Access Compliance Report Public Rights-of-Way (Pedestrian Signals)

Intersection ID: N/A	Main Street:	Cross Street: N/A	Location: N/A
ADA ID: 81DD91ED6F8E	Signal Type: Two Push Buttons-APS	Overall Compliance: No	Severity Score: BTN 1:N/A BTN 2: N/A No BTN: N/A
Codes/Mitigation Info/Possible Solution		Field Measurements/Component Compliance

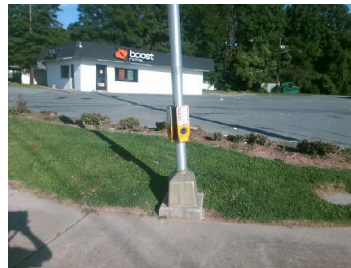
Surveyor Notes: TEXT HT 5/16

PROW/ADA: R410.6, R209.1, TMUTCD 4e.08, R404.2, R404.3, R406.2, MUTCD 4e.08, , R404.7.3

Possible Solutions: Replace Signal Push Button With APS Button on New Post.
Remove & Replace Sign. Remove & Replace Replace APS Button With New APS Button.
Remove and Replace Clear Space.
